CHANGES AS SUBMITTED IN S4.55 -
UNDER REVIEW - MOD/2024/0225

1728 Fortis South Steyne

34-35 South Steyne Manly NSW

GA Elevation
East & West Elevation

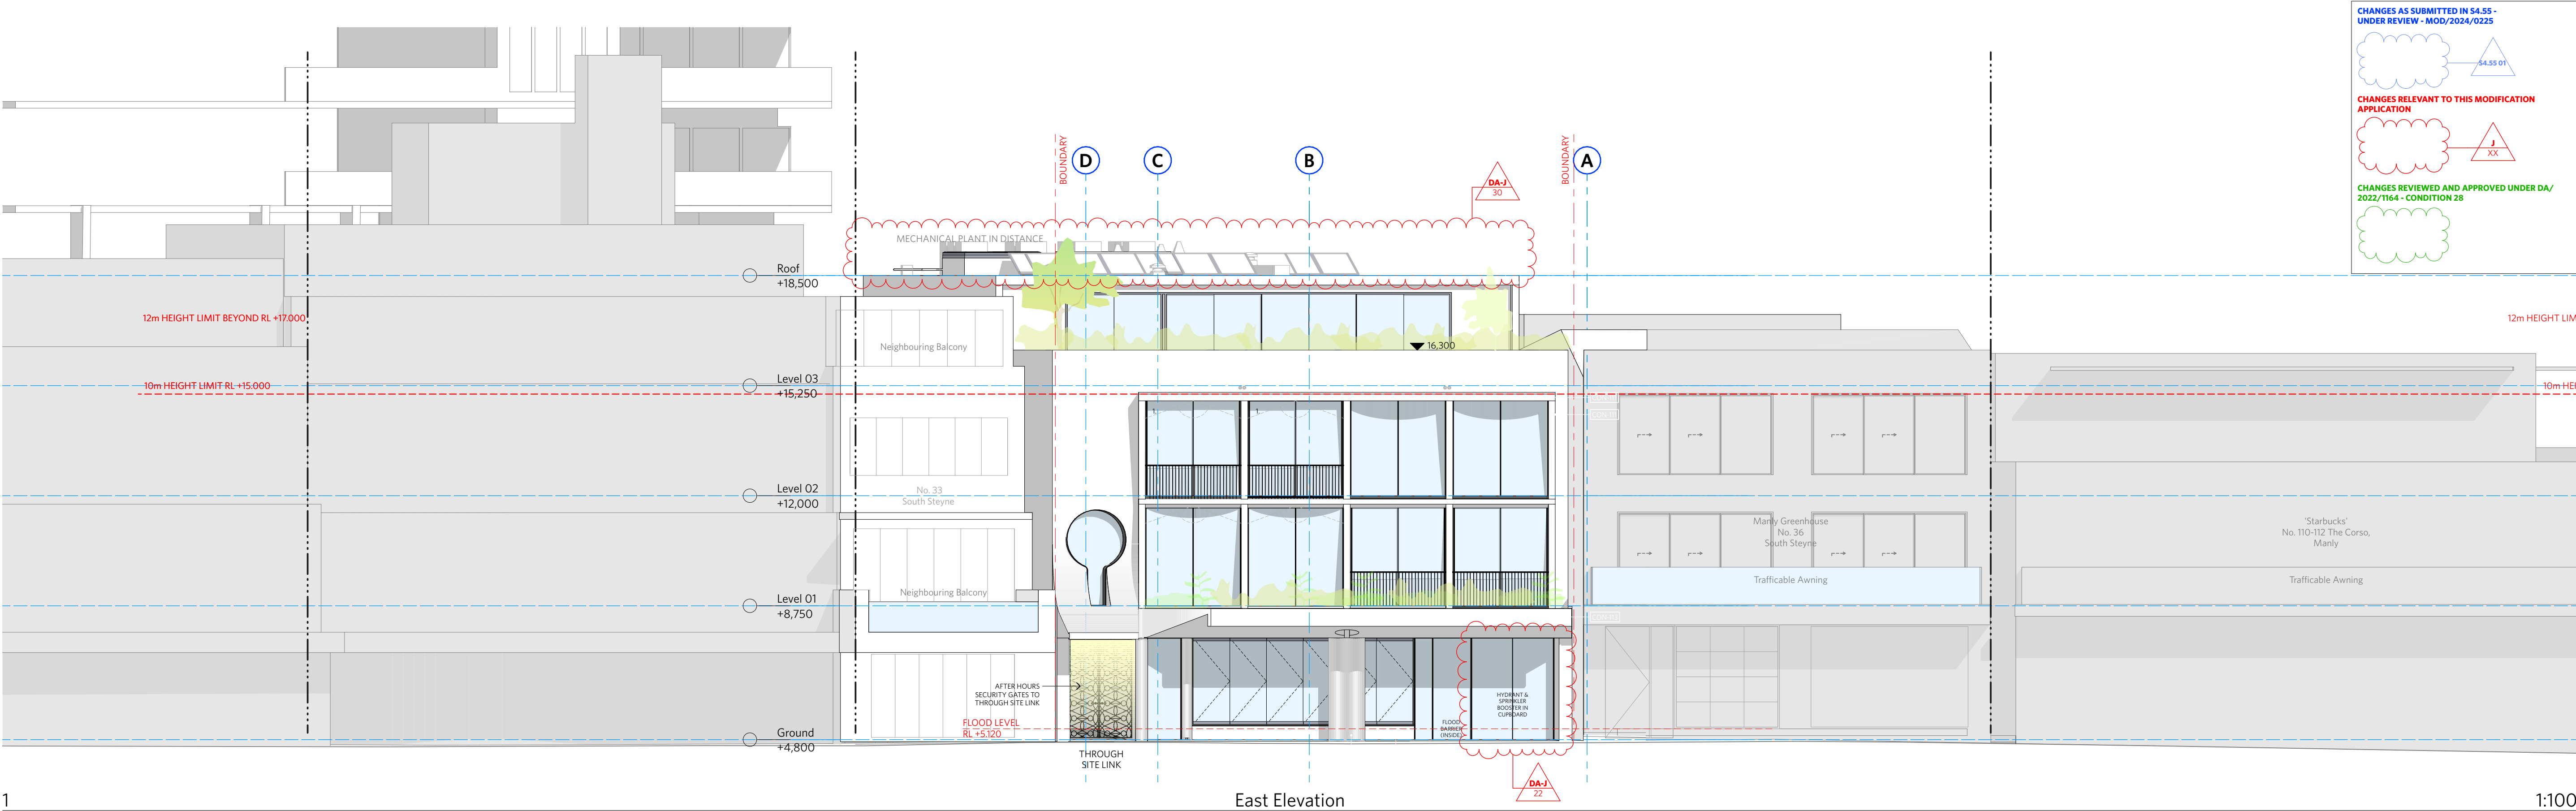
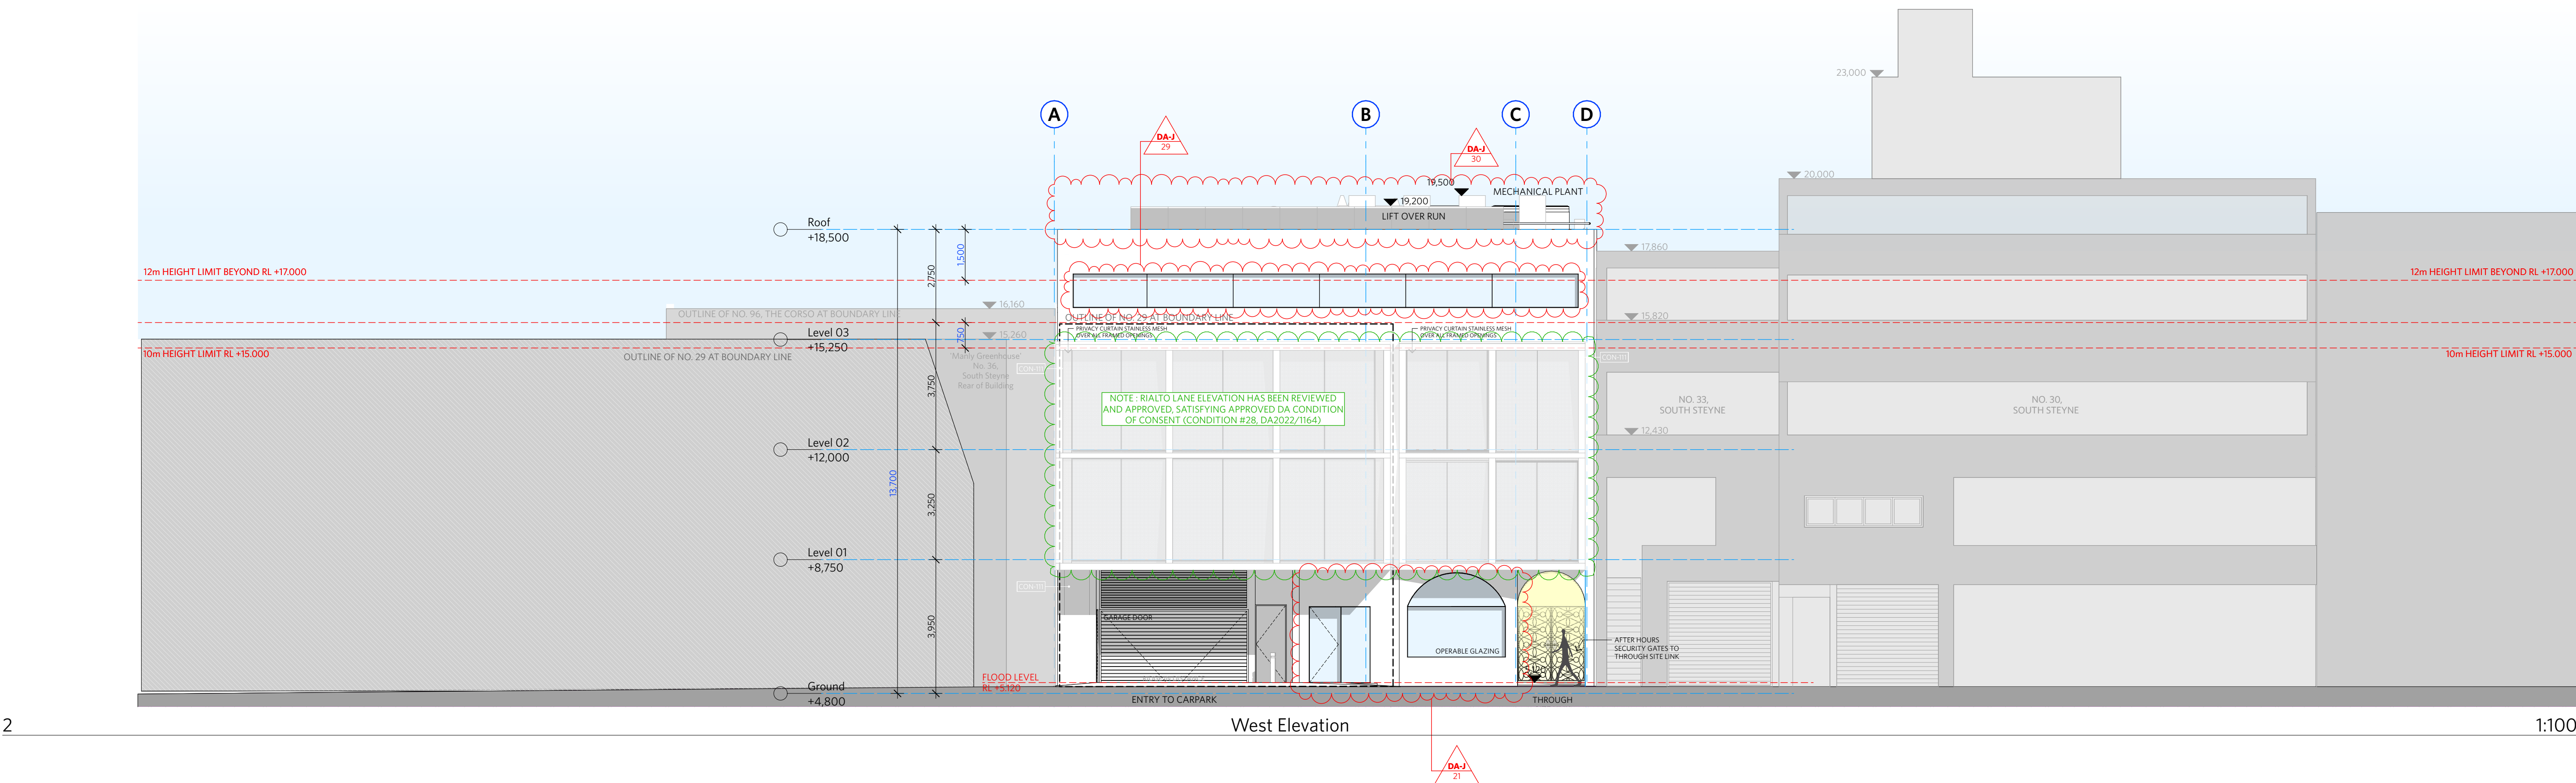
REV	CHANGE	DESCRIPTION
21		Additional openings added into Ground floor Tenancy
22		Relocation of Sprinkler Booster to South Steyne
29		Changes to window openings to the west to suit new form
30		Revised Roof Layout to suit new form, including Revised Mechanical, Solar & other Equipment

Section AA, BB & EE

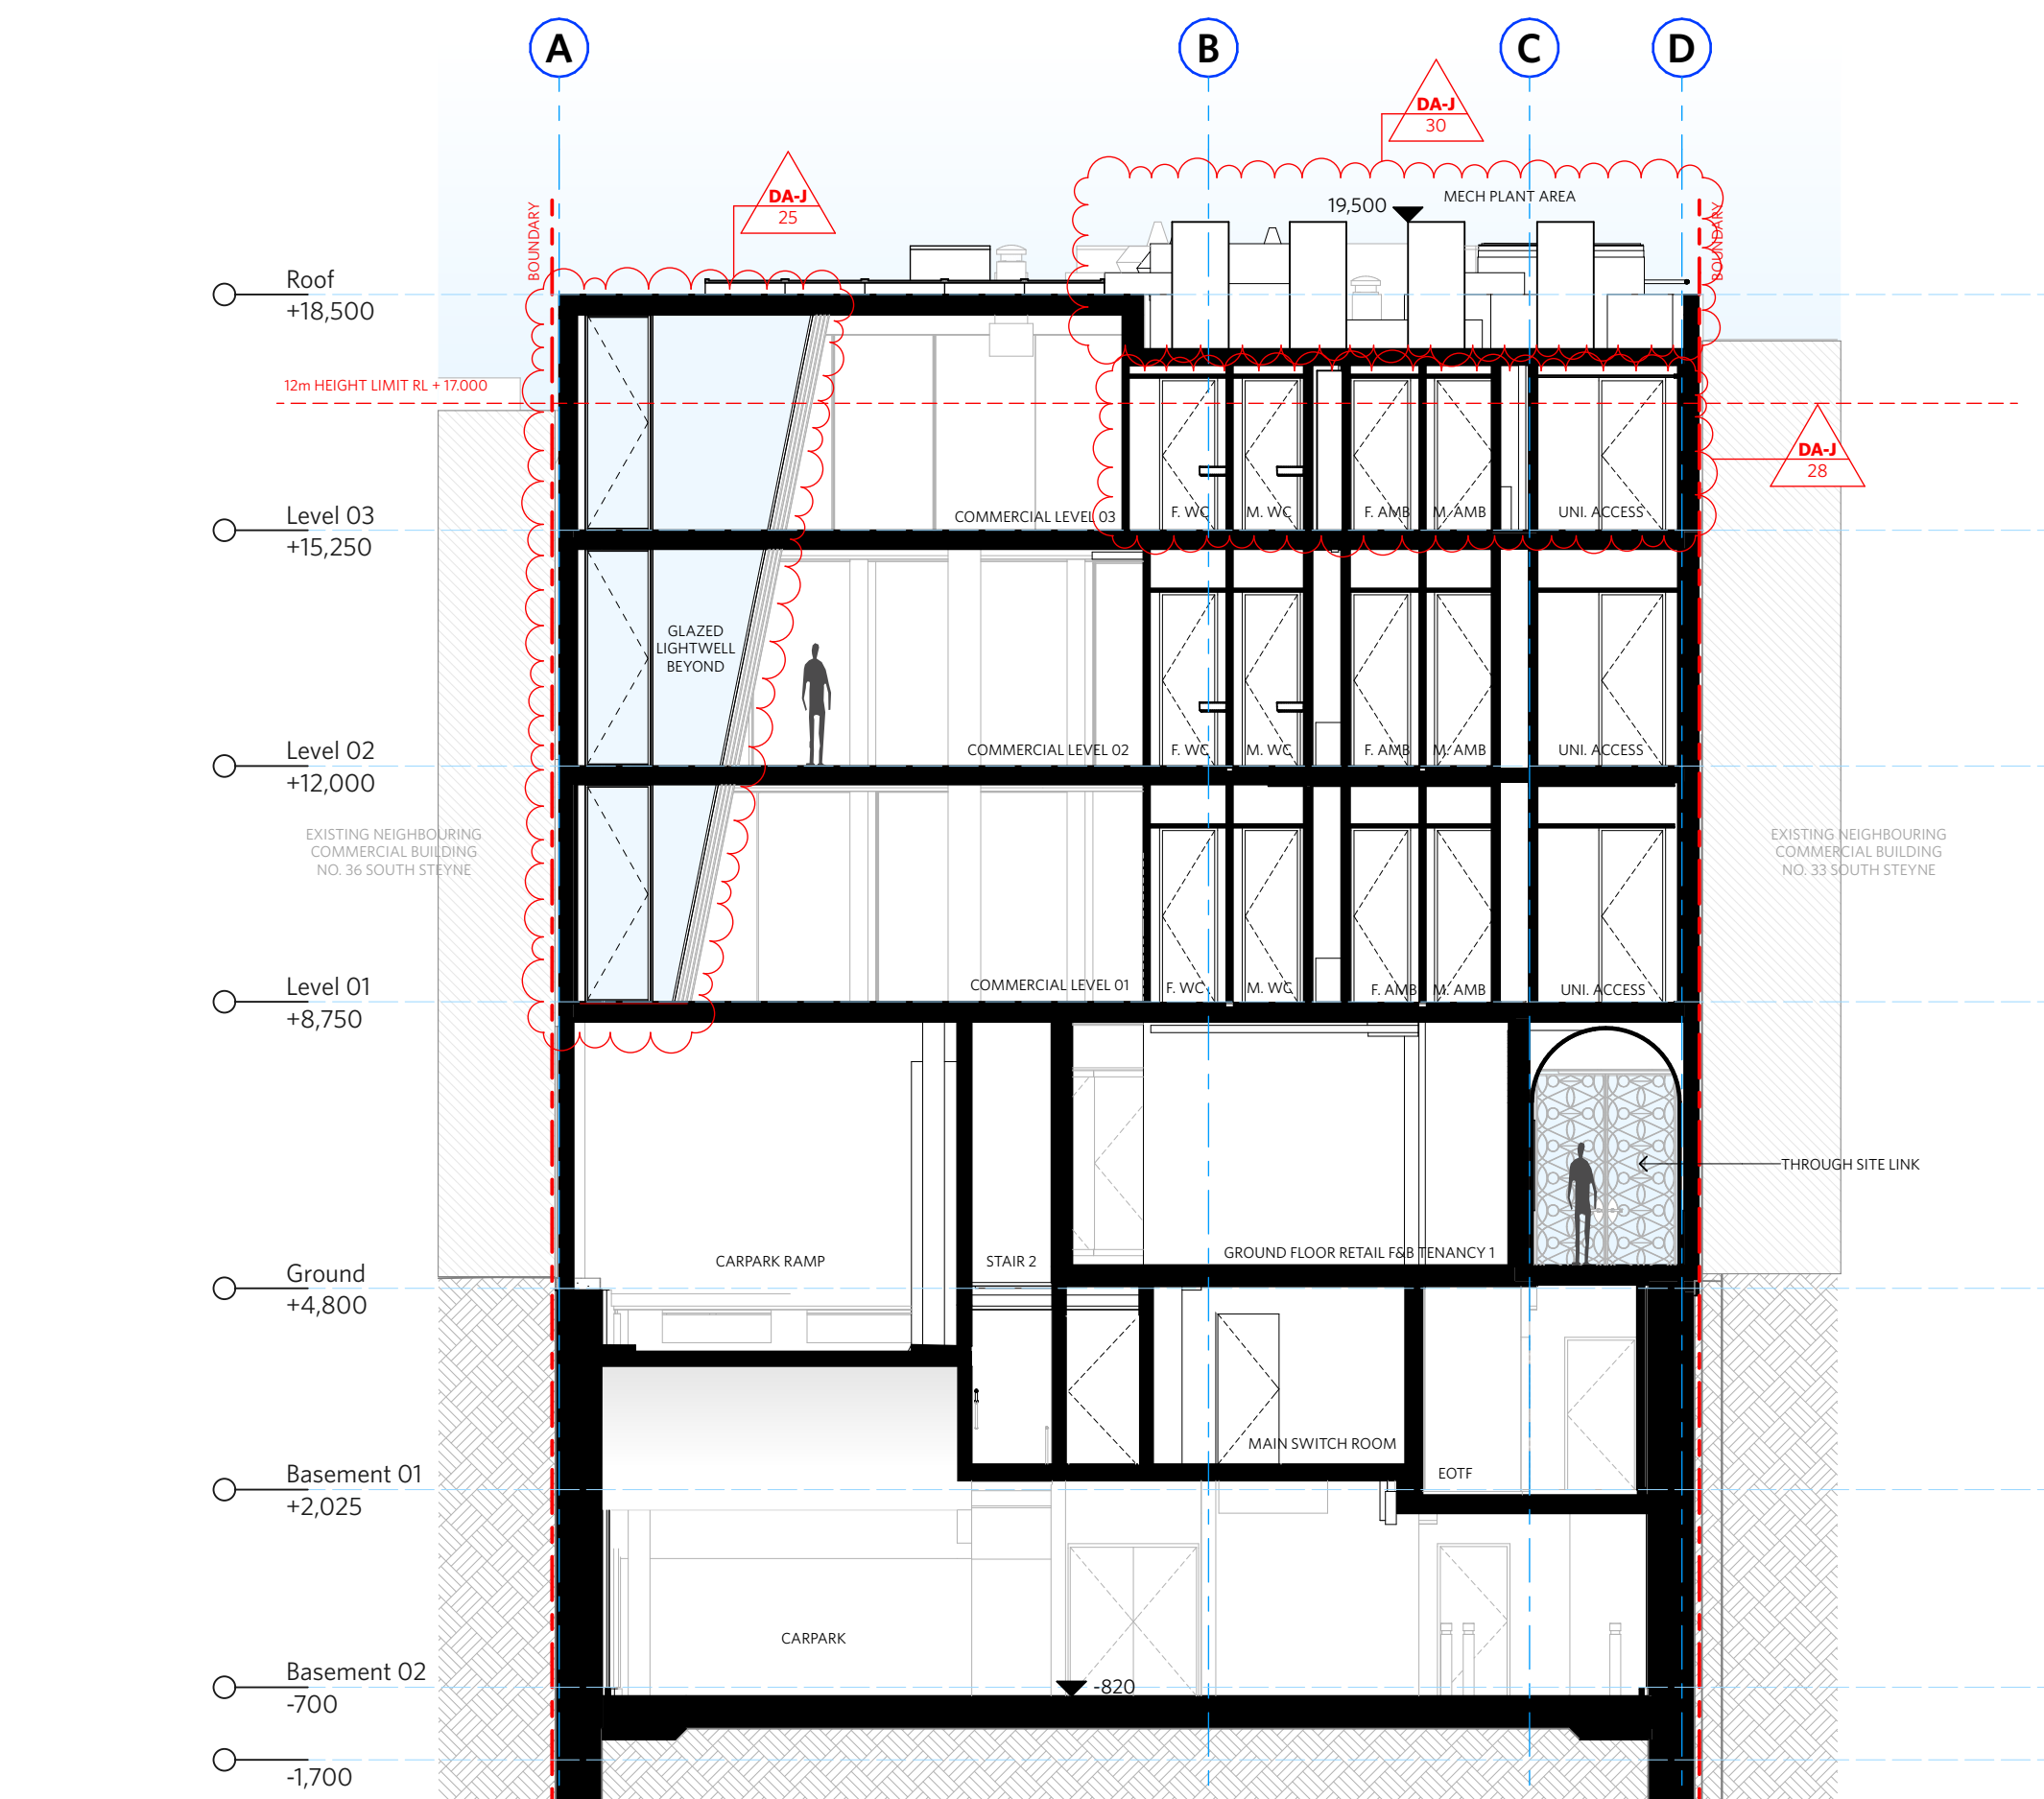
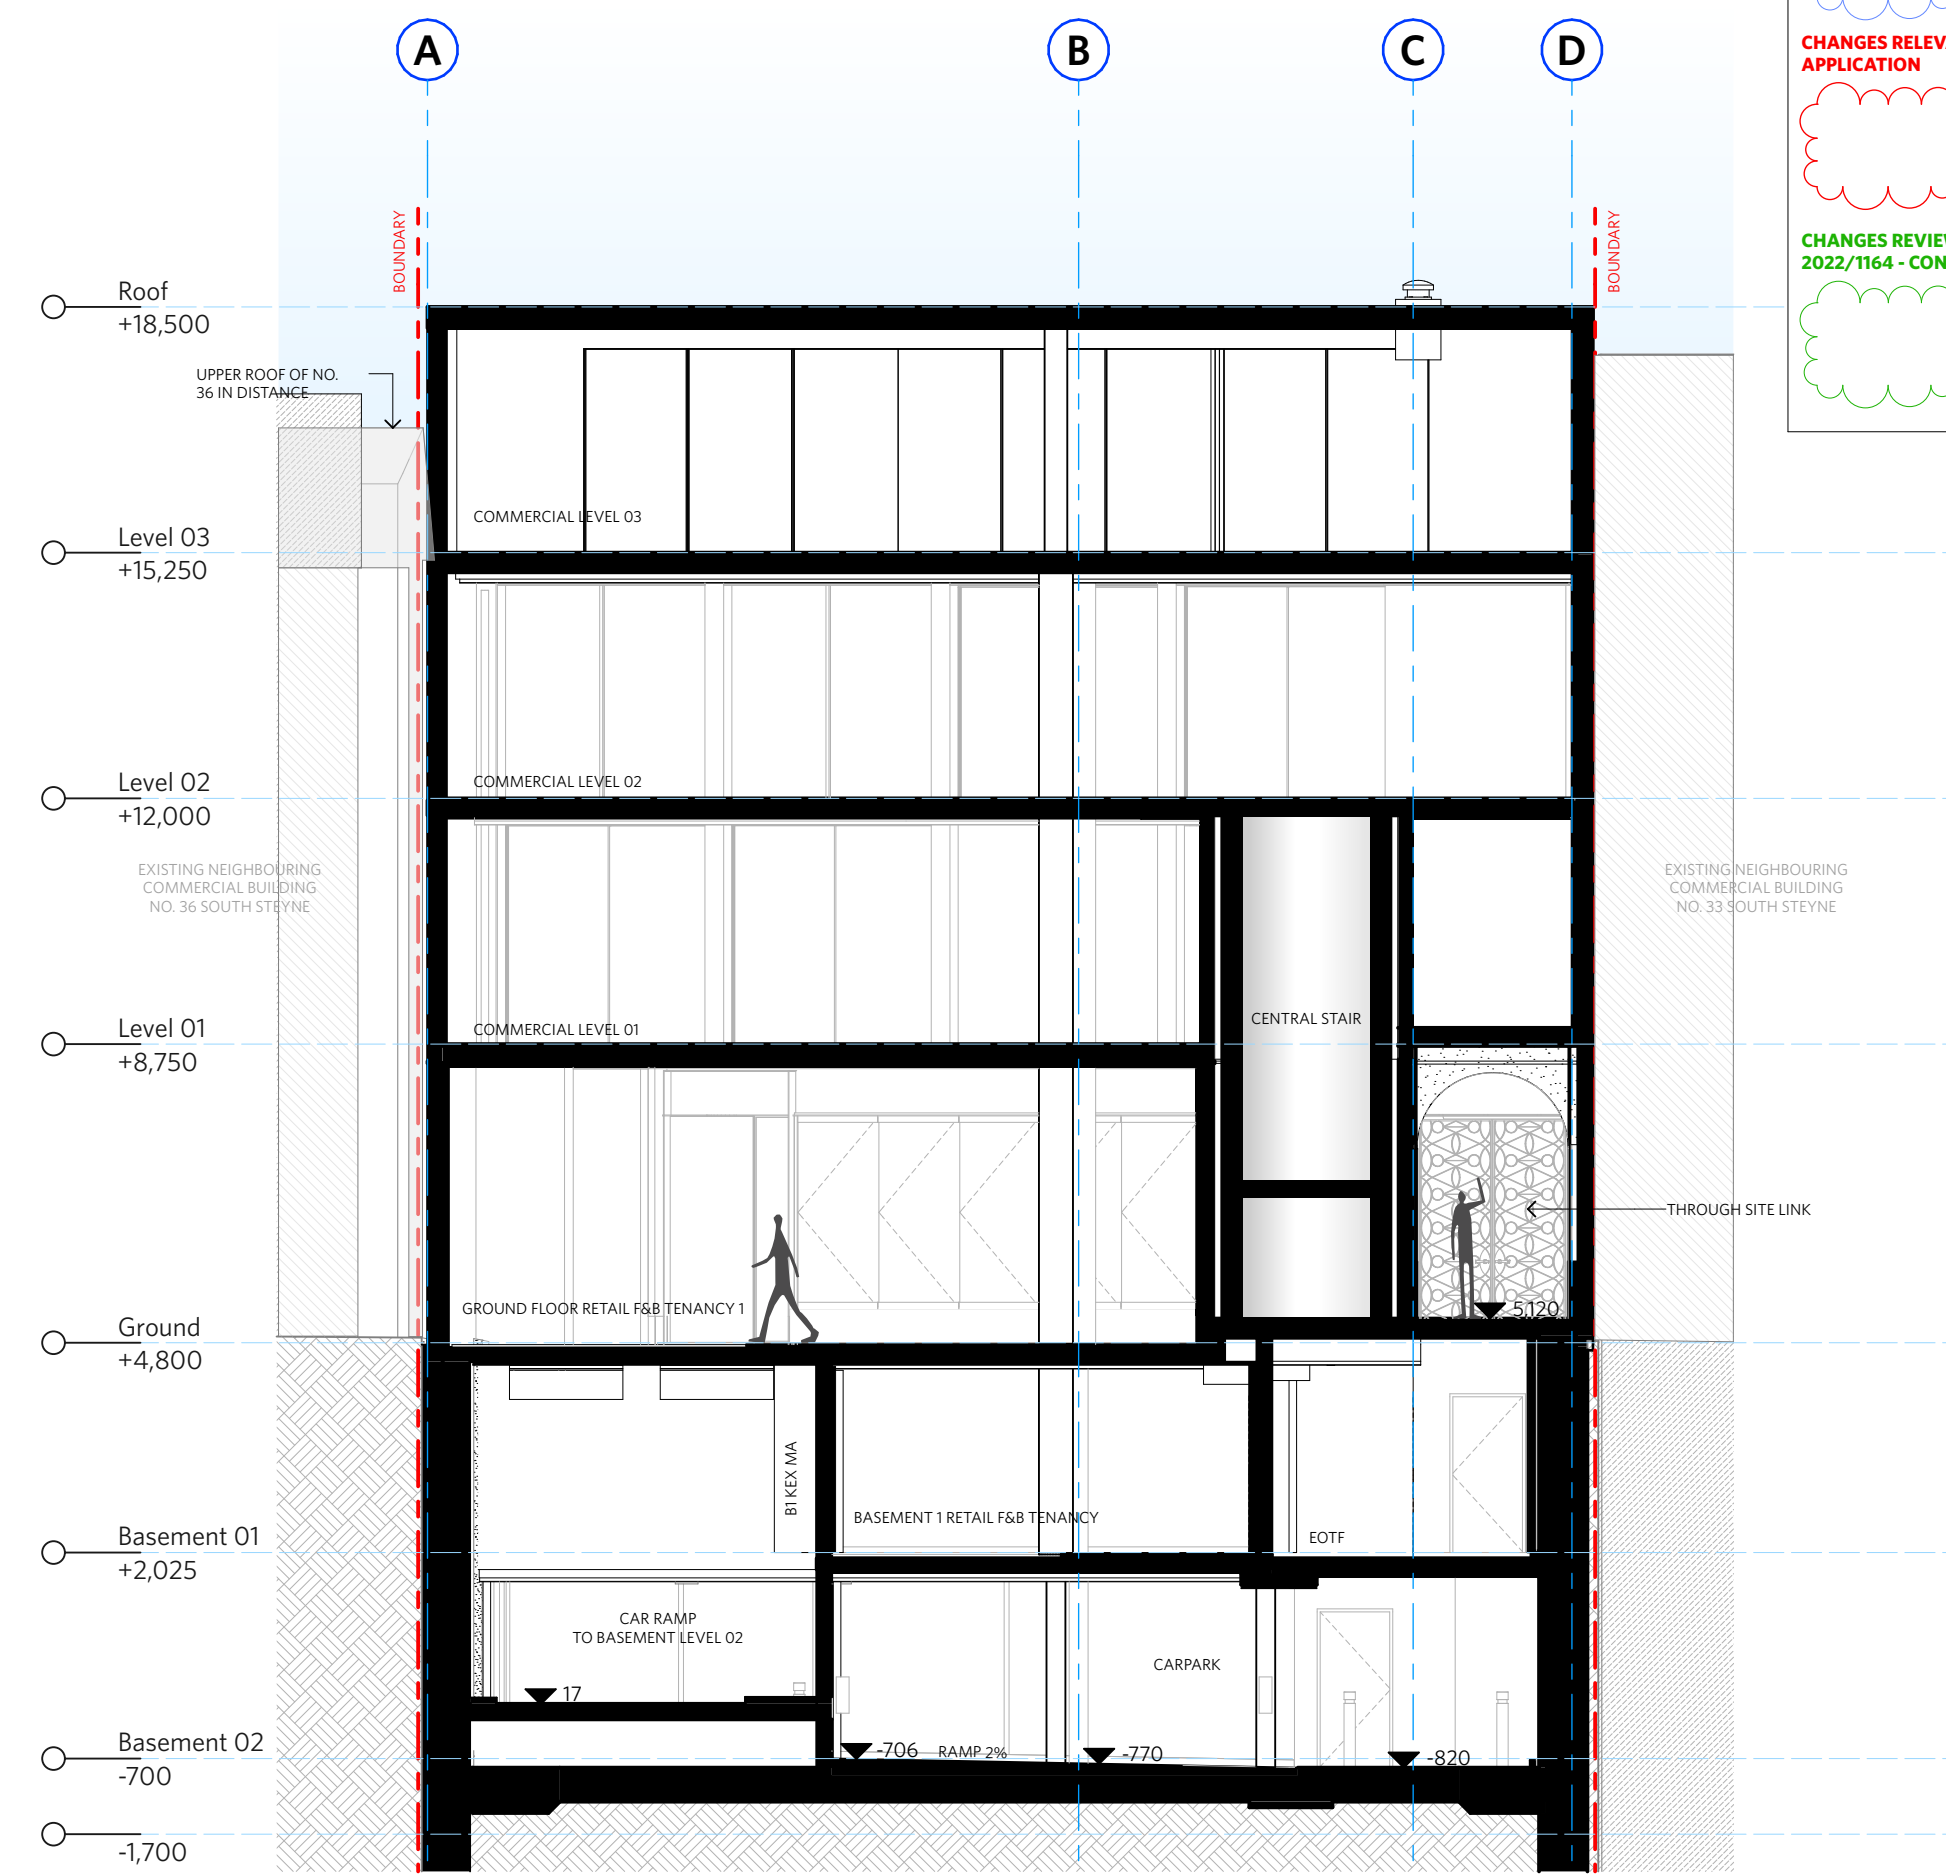
REV	CHANGE	DESCRIPTION
	17	Amendments to Central Stair
	21	Additional openings added into Ground Floor Tenancy
	23	Sliding Fire Door Added to Through Site Link
A-1	25	Changes to the Central Courtyard
	27	Increase in Floor Space to the west
	28	Changes to the Amenities to suit revised floor plate
	30	Revised Roof Layout to suit new form, including Revised Mechanical, Solar & other Equipment
